TRANS/WP.29/694

Working Party on the Construction of Vehicles

DRAFT 05 SERIES OF AMENDMENTS TO REGULATION No. 22 (Protective helmets)

Figure 1b: Example of a suitable test apparatus for projections and surface friction (method A)

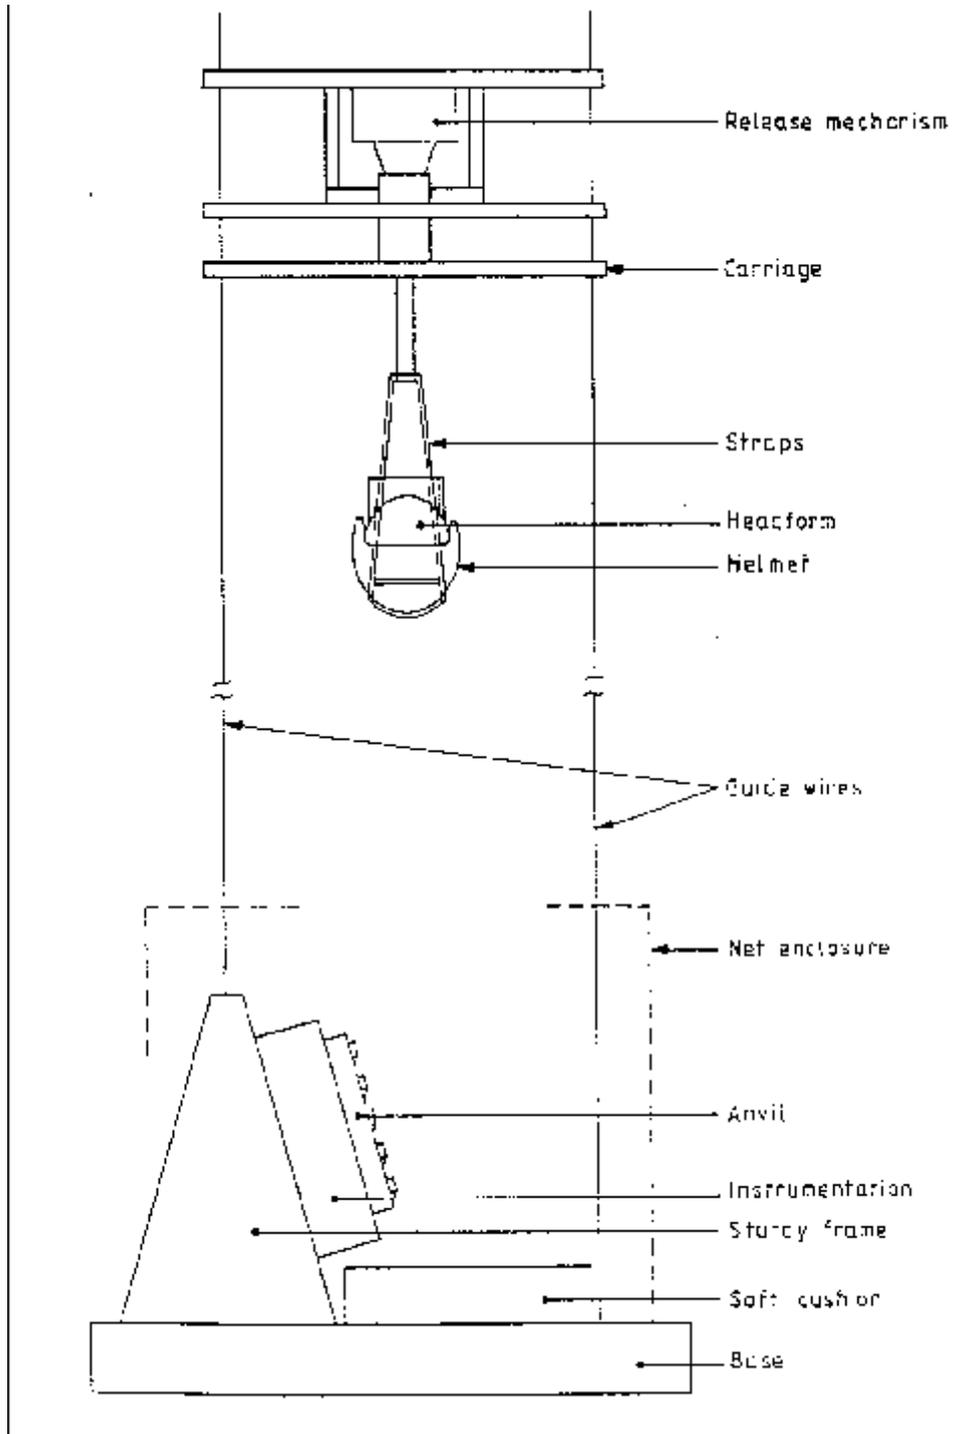
Insert new Figures 1b and 1c, to read:

Figure 3: Arrangement of Apparatus for Measurement of Light Diffusion - Method (c)

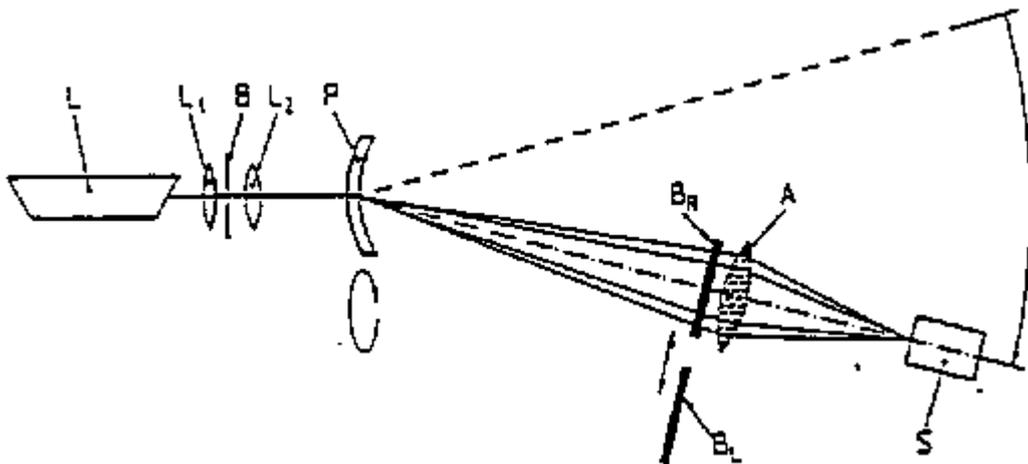
Insert new paragraphs 3. to 3.2.2. and figure 3, to read:

Type approval scheme (Flow chart)

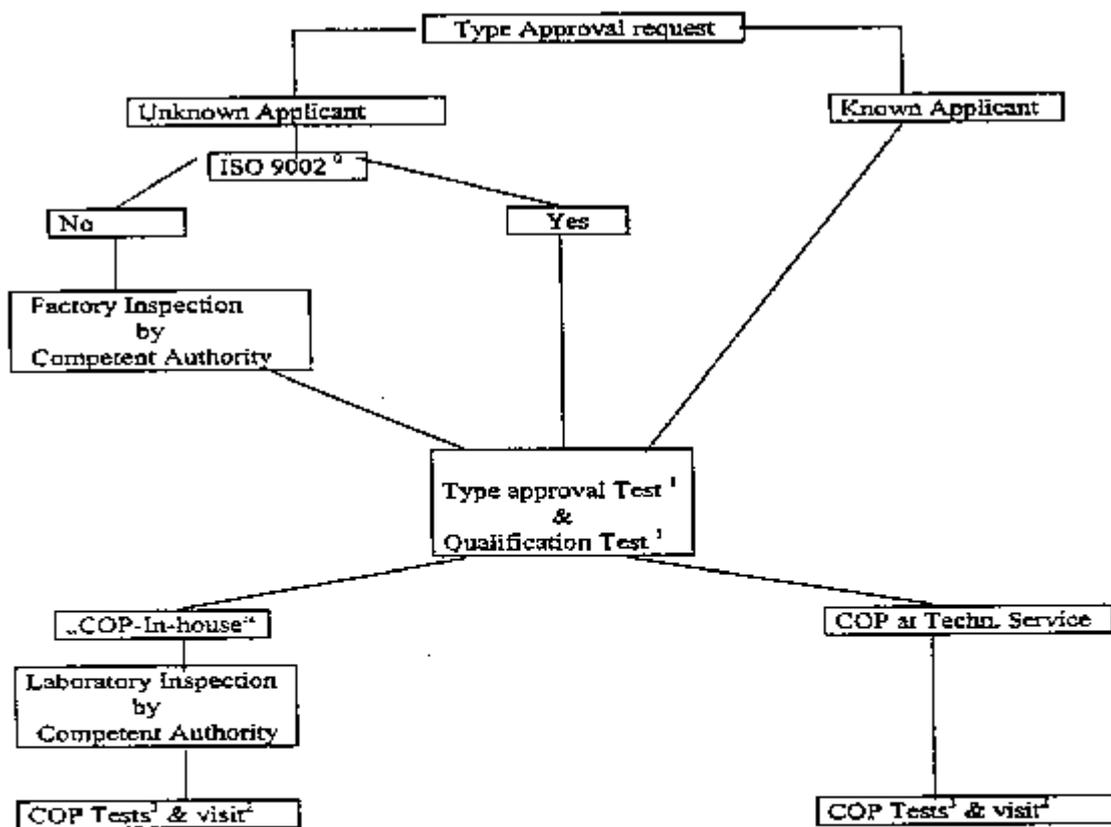
Insert new annexes 12 to 16, to read:
